Item ID: D206-667-103

Item Name: Crosstube Fwd

DRAWING NO. D206-667-143	TITLE CROSSTUBE ASS'Y (206L HIGH FWD)	REV. C	DART AEROSPACE LTD ENGINEERING ORDER		D.E.O. NO. D206-667-143-C-1	SHEET NO. SHEET 1 OF 1	SCALE NTS
DRAWN 92	CHECKED ASS	MFG. APPR. [Signature]	APPROVED [Signature]		DE APPR. [Signature]		
DATE 11.07.15	DATE 11.07.20	DATE 11.07.21	DATE 11/07/21		DATE 11.07.21

DRAWING NO. D206-667-143	TITLE CROSSTUBE ASS'Y (206L HIGH FWD)	REV. C	DART AEROSPACE LTD ENGINEERING ORDER		D.E.O. NO. D206-667-143-C-2	SHEET NO. SHEET 1 OF 1	SCALE NTS
DRAWN AJS	CHECKED	MFG. APPR. <i>E</i>	APPROVED <i>AP</i>	DE APPR. <i>AP</i>			
DATE 12.08.02	DATE 12.08.02	DATE 12.08.02	DATE 12.08.02	DATE 12.08.02

DETAIL P
BONDING STRAP INSTALLATION 2 PL

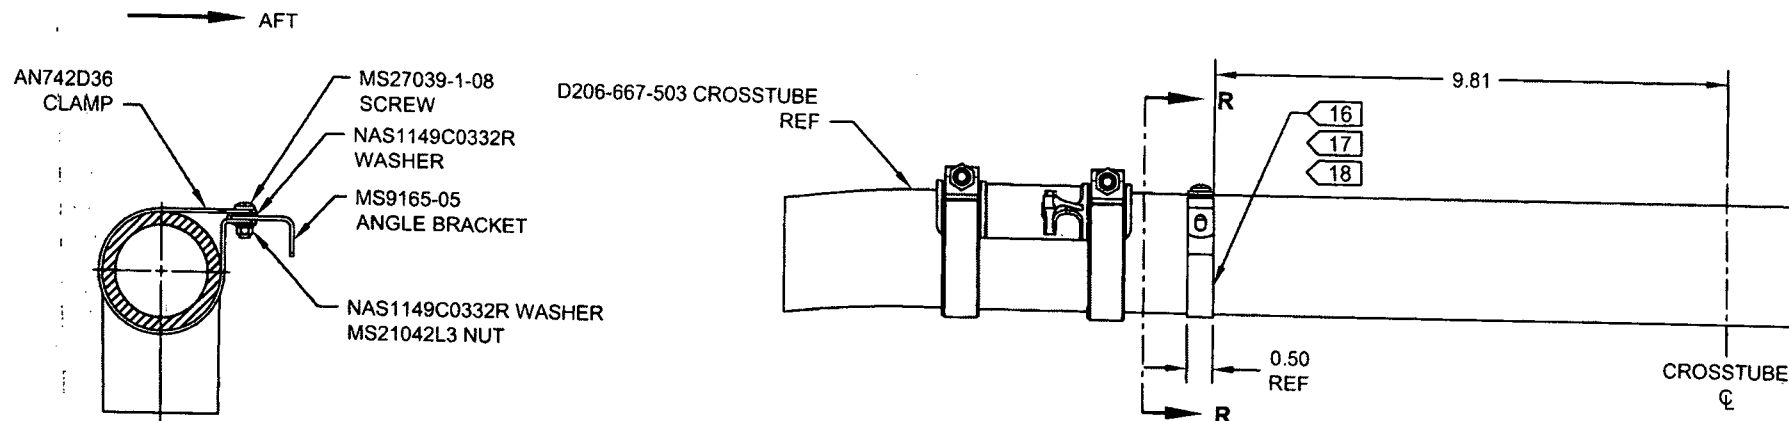
ADD ELECTRICAL GROUNDING STRAP

ADD
